Re: **Well Installation Work Plan Addendum**  
1137-1167 65<sup>th</sup> Street  
Oakland, California  
Cambria Project # 522-1000  
Case No. RO0000082

On behalf of John Nady, Cambria Environmental Technology, Inc. (Cambria) has prepared this *Well Installation Work Plan Addendum* (Addendum) for the above referenced site. This Addendum is based on a March 10, 2004 email and March 11, 2004 telephone discussions with the Alameda County Health Care Services Agency (ACHCSA) regarding Cambria's *Interim Investigation Data Report* (Interim Report) dated February 24, 2004. As requested by the ACHCSA, this Addendum proposes two additional wells in the Zone A water-bearing zone.

FIGURE 1

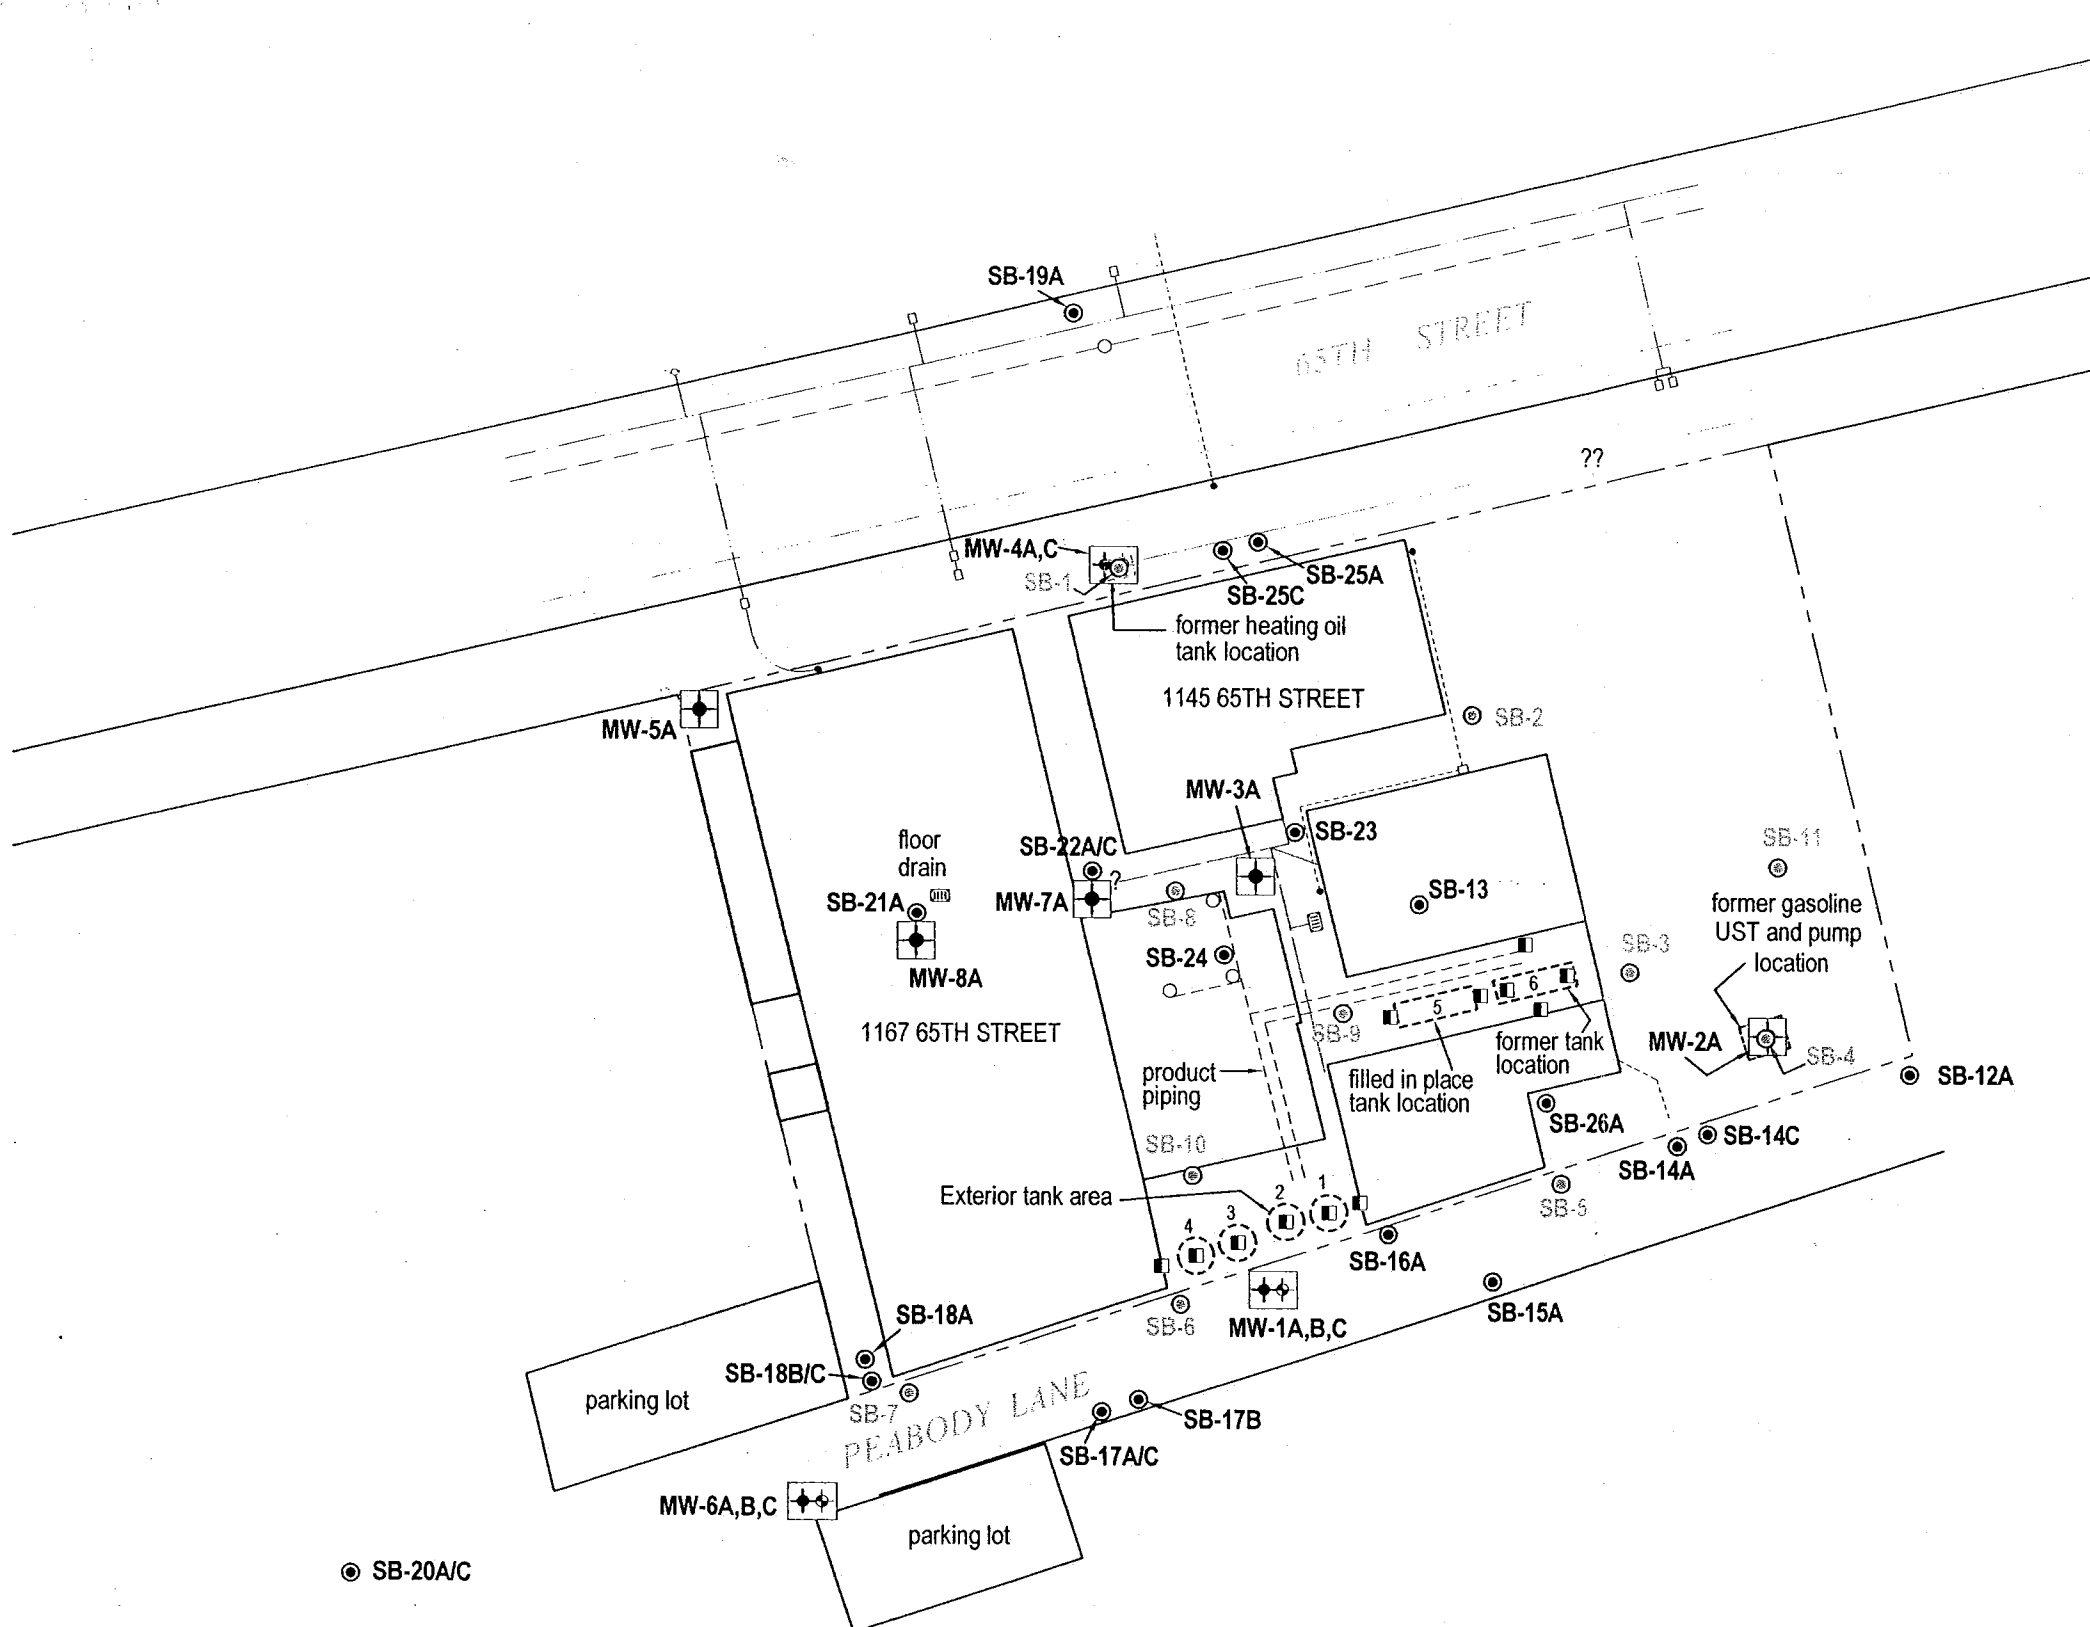
- \* Is there possible source near SB-21 and the floor drain? GW concentrations were high. Would it be possible to add a well near SB-21 or near the STEP boring just sw of SB-21?
- \* Is it possible/reasonable to have a mw near the inner tanks 5&6 since we know there is high residual soil contamination left in place.
- \* Could the location of proposed well MW3 be moved west, near SB-8 which exhibited very high soil and gw concentrations?

The Interim Report proposes installation of the following wells in the A, B, and C water-bearing zones: MW-1A through MW-6A; MW-1B and MW-6B; and MW-1C, MW-4C, and MW-6C. The additional scope of work to be performed by Cambria will include the drilling and installation of the following two monitoring wells screened across the Zone A water-bearing zone (see Figure 1):

- Monitoring well MW-7A will be in the vicinity of previous boring SB-22.
- Monitoring well MW-8A will be in the vicinity of previous boring SB-21, and drilled using a hand auger to install a pre-packed well.

As we discussed during our March 11, 2004 telephone discussion, Cambria is not proposing a well in the vicinity of the former inner tanks 5 and 6 due to tank 5 having been filled in place and no shallow groundwater encountered in previous borings in the vicinity (SB-3 and SB-9).
